1 CHANNEL SHOWN

POWER SUPPLY

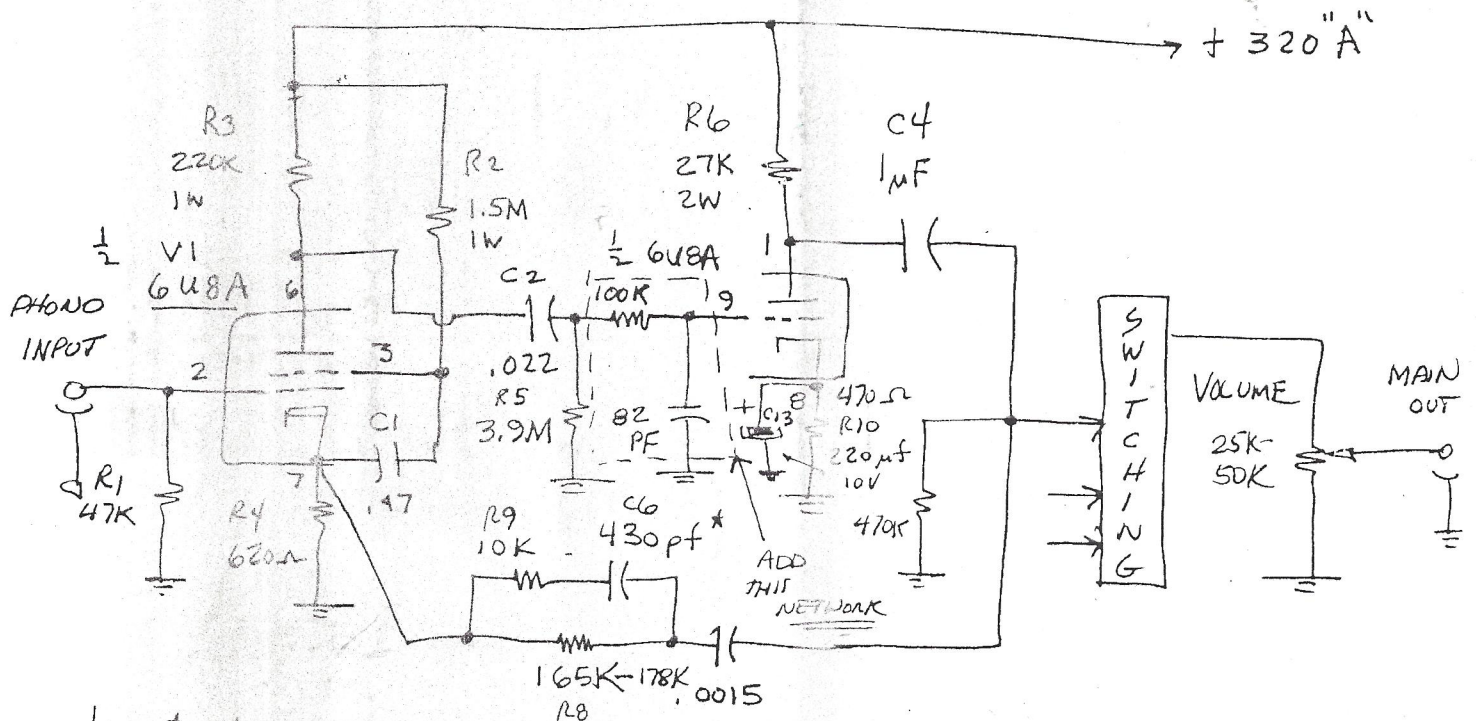
1. A CHANGE TO 390PF-400PF C5 IF NETWORK IS ADDED.
2. CHANGE .47µF, 1µF, .022µF to Polyprop.
3. CHANGE ALL 100µF CDE'S TO SPRAGUE OR SOME OTHER RELIABLE ELECTROLYTICS
